1. SURVEY SUMMARY *(40 min.)*
 - METHODOLOGY
 - PARTICIPANTS
 - MONTAGE DEVELOPMENT PARK
 - BADGER PARK + RIVER ACCESS
2. NEXT STEPS *(10 min.)*

HEALDSBURG PARKS DESIGN + RIVER ACCESS | CITY OF HEALDSBURG COMMUNITY SERVICES | FLETCHER STUDIO

MASTER PLAN

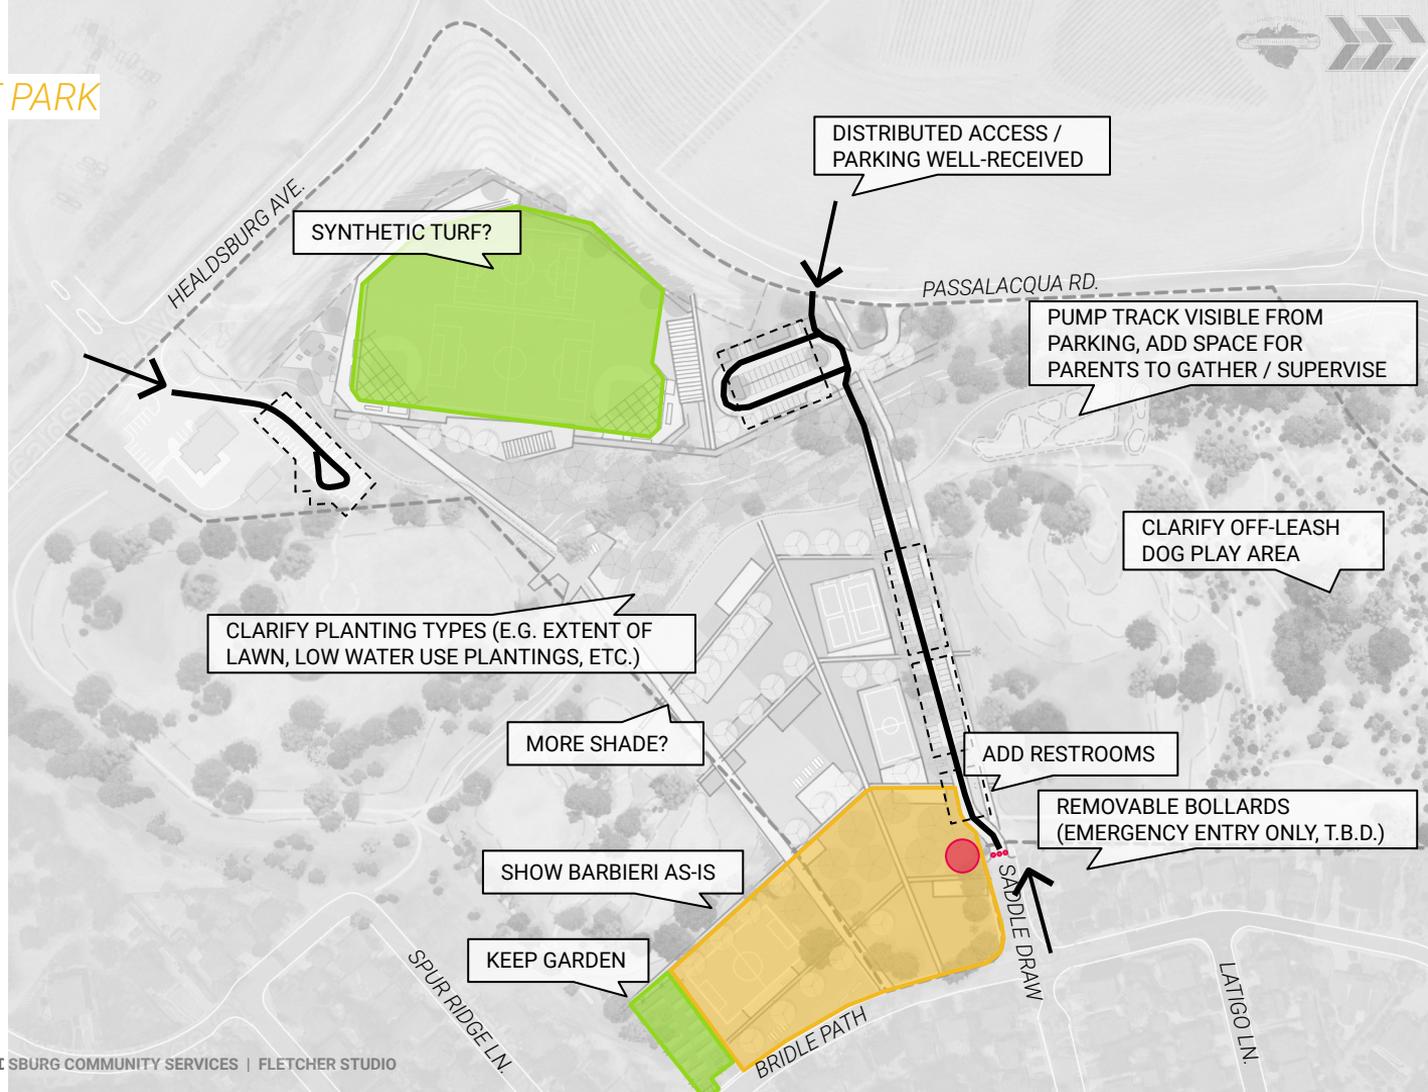
- Keep Barbieri Park as-is for the timebeing; this will be studied further in subsequent 'Detailed Design' phase
- Add space for parents to gather while watching children playing
- Support for primary park access from Passalaqua and Healdsburg Ave.; add removable bollards at Saddle Draw
- Support for clustered parking approach.
- Support for new fire substation.
- To work on further during Detailed Design phase:
 - Increase shade.
 - Lighting compliant with dark sky cutoffs and natural environment.
 - Clarify low water use plantings, meadows, hybrid bermuda grass and synthetic turf areas.

MASTER PLAN

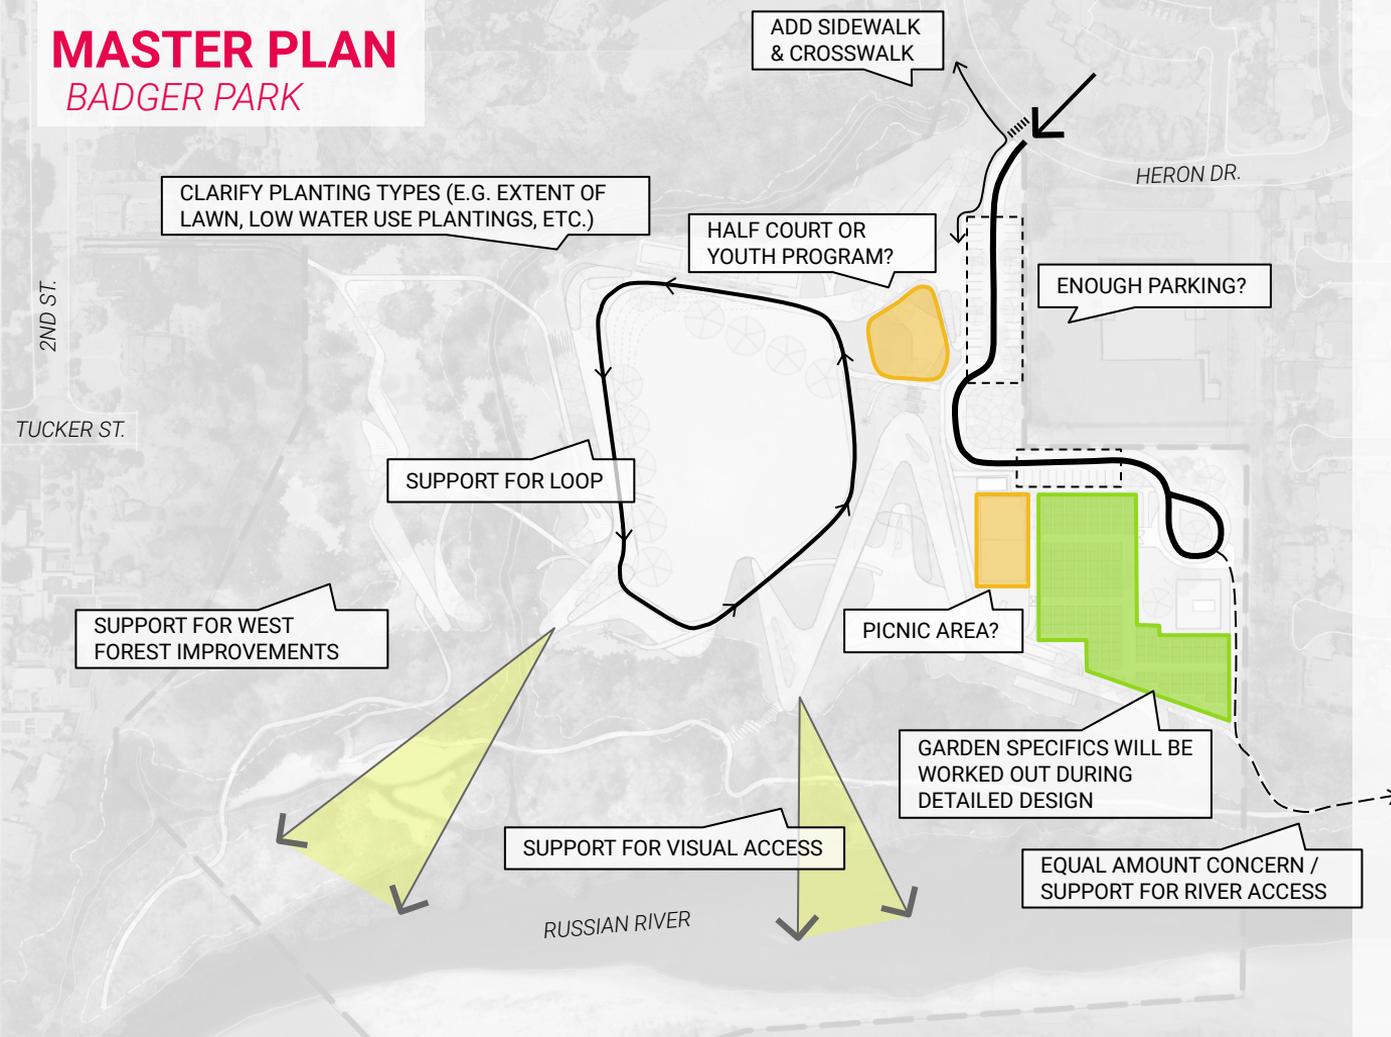
- Overall positive reaction to masterplan
- Confirm proposed parking qty. is adequate to support proposed uses (river access, games, weekend activities)
- Support for keeping a walking loop, but with a surface that is less slippery during winter months.
- Equal amount of concern / support regarding river access.
- Some preference for keeping the dog play area in its current location, due to amount of insects that may be at proposed location.
- To work on further during Detailed Design phase:
 - Community garden specifics, e.g. how beds will be phased as gardeners vacate plots to make room for possible parking.
 - Clarify low water use plantings, meadows, hybrid bermuda grass and synthetic turf areas.
